G-AREA STORM DRAIN BASIN STUDY

City of Lodi Public Works Department

January 20, 1983

RE: G-Area Basin Study

Fig 6-3 ALTERNATE STORM DRAINAGE
 EXHIBIT 3
 ALTERNATE A
 TWO BASINS
 LODI URBAN DRAINAGE AREA

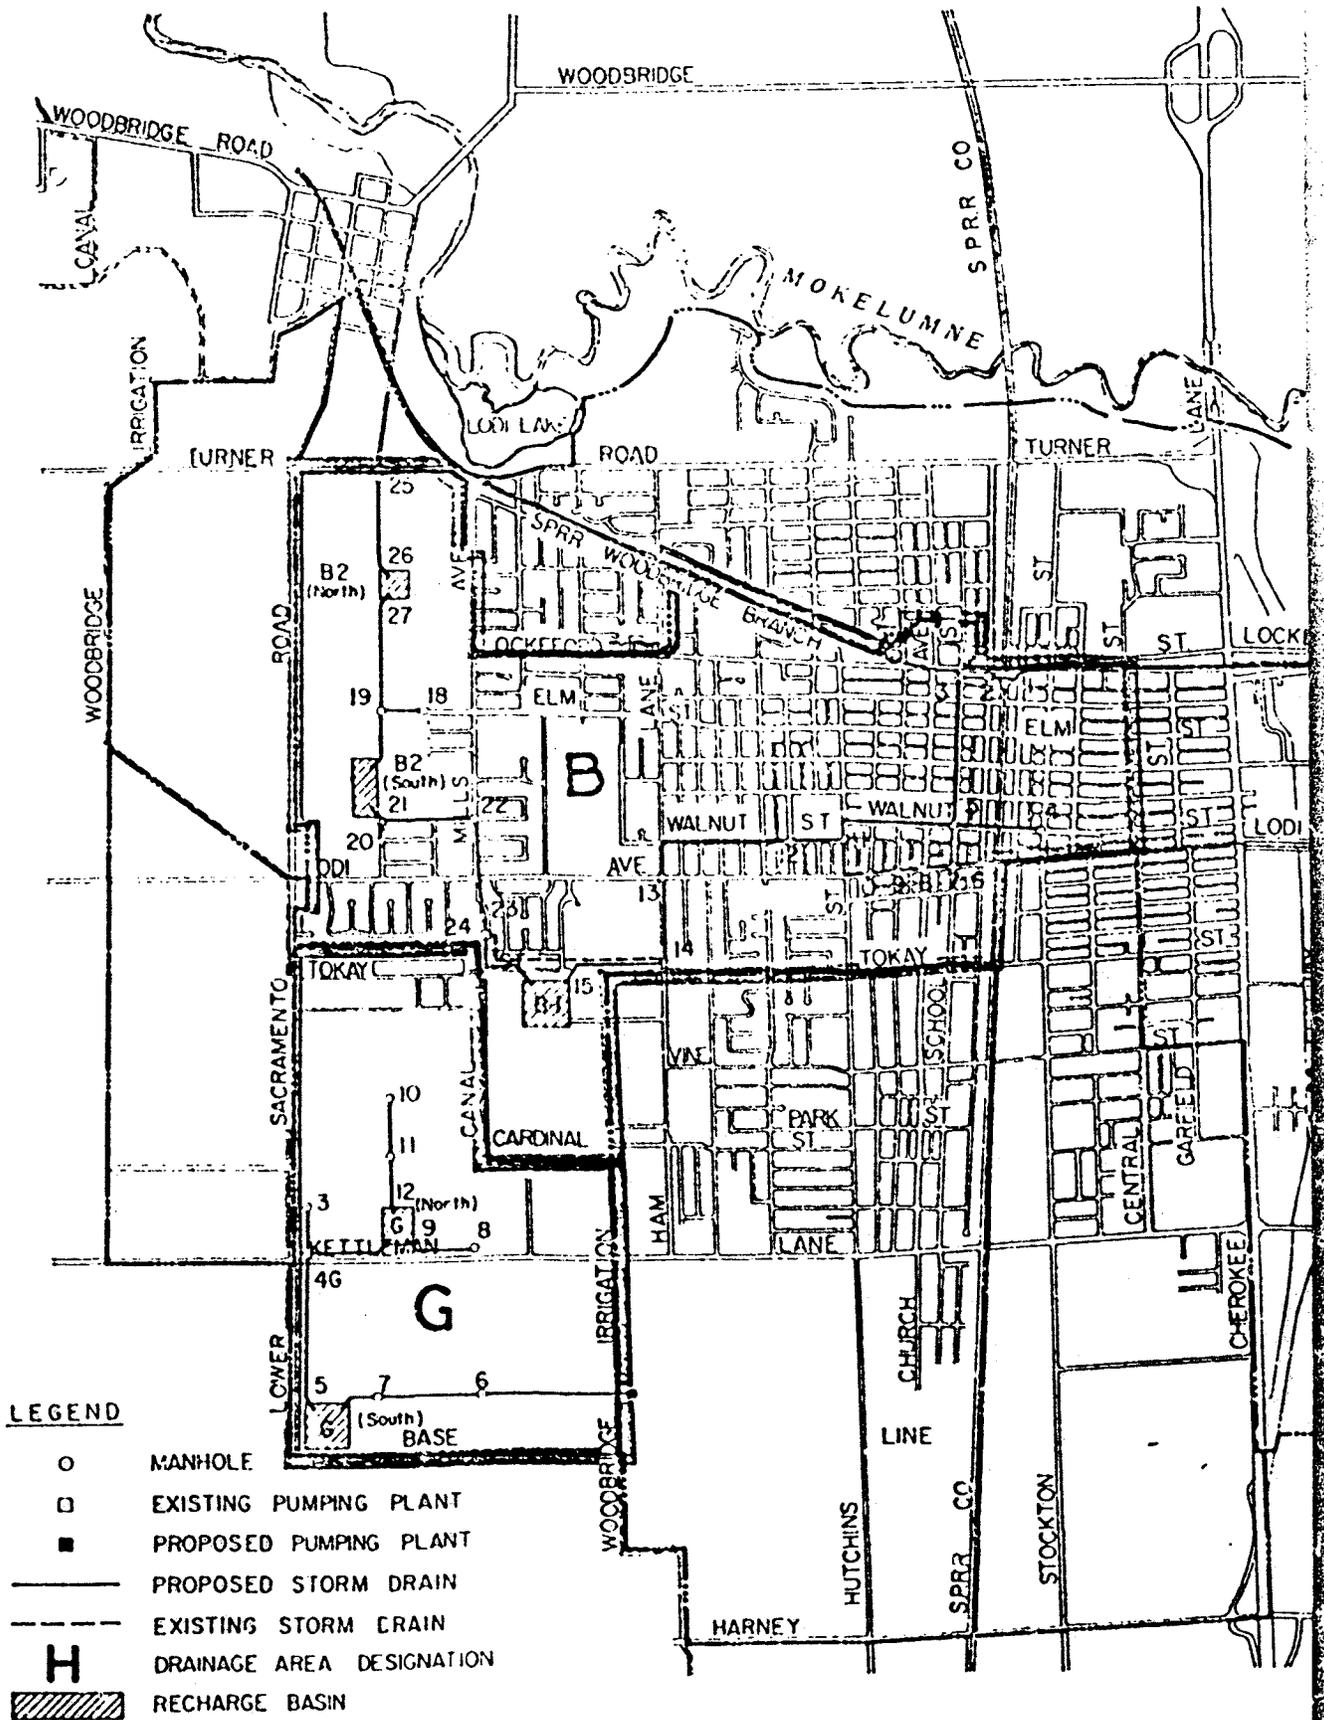
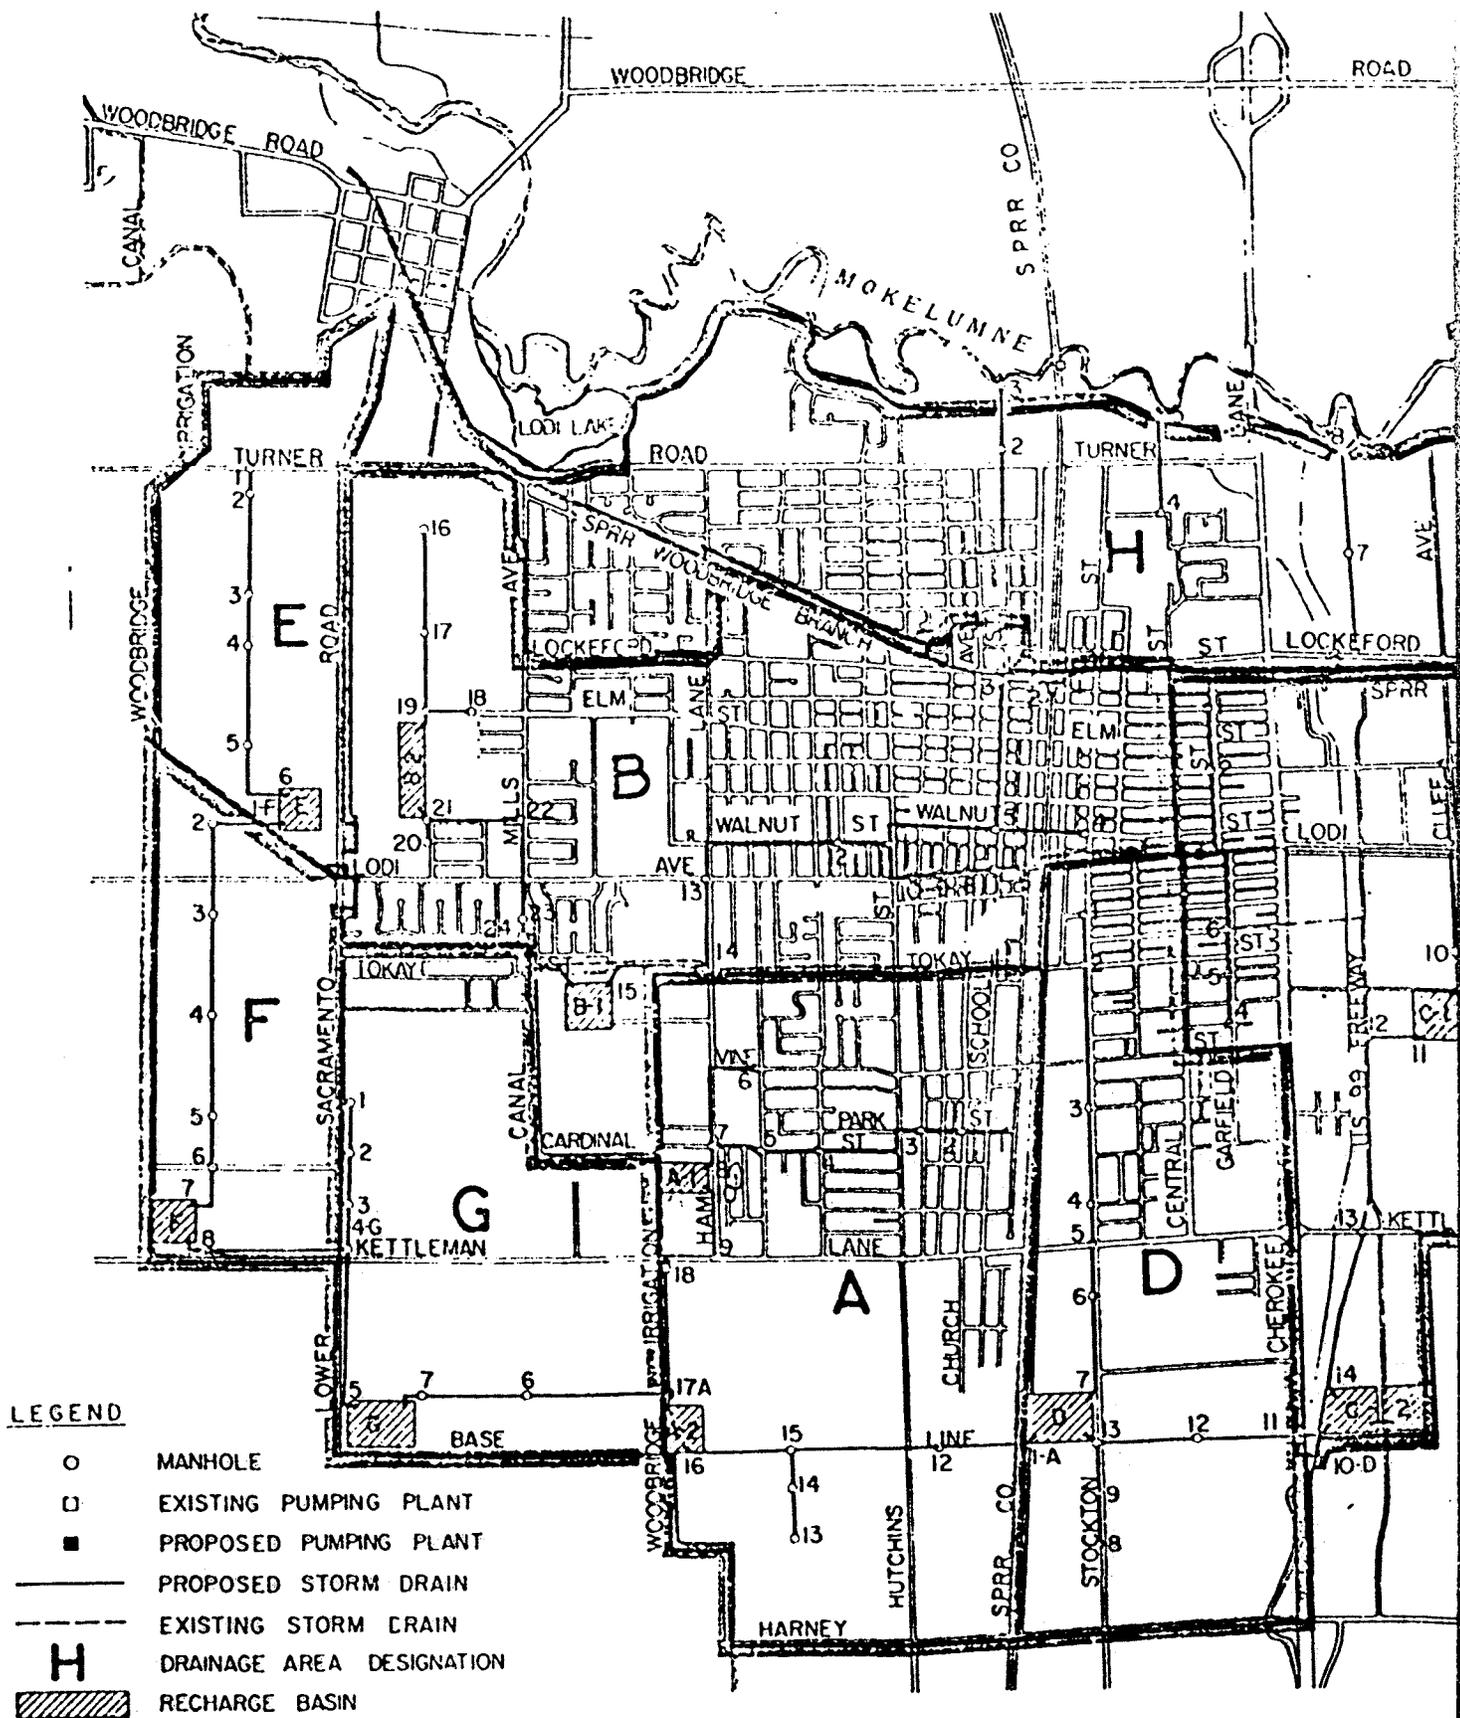
I believe it would be in the best interest of the City to have one basin for operation and maintenance. Initial costs of two basins with pumps, electrical controls and telemetering, landscaping, etc., would be more costly.

Gs Basin is necessary under any option, and if you decide to use two basins and build Gn Basin, the Gn Basin will not function without Gs Basin.

The area immediately north of Kettleman Lane (between Kettleman Lane and the south line of proposed Sunwest IV) may be better served by a line running south through the Lobaugh property to the Gn Basin. The line should have been run in Mills Avenue location and would have better divided the area. The plan as shown proposes all the drainage run westerly to Lower Sacramento Road and then southerly. We also believe there should be a line in Lower Sacramento Road to serve the area in the future "F" Basin area and possibly future development along Lower Sacramento Road. This would also provide a certain amount of flexibility and perhaps allow development that would not be totally dependent on other developers.

In regards to the proposed Sunwest No. 4 development, we would recommend eliminating the Gn Basin and provide a pipeline down Lower Sacramento Road and build the northerly portion of Gs Basin. We also recommend that the master plan provide for a line from the area north of Kettleman Lane through the Lobaugh property to the Gs Basin. This area is too big to not have a master line not run through it. This would provide the greatest amount of flexibility to the entire area.
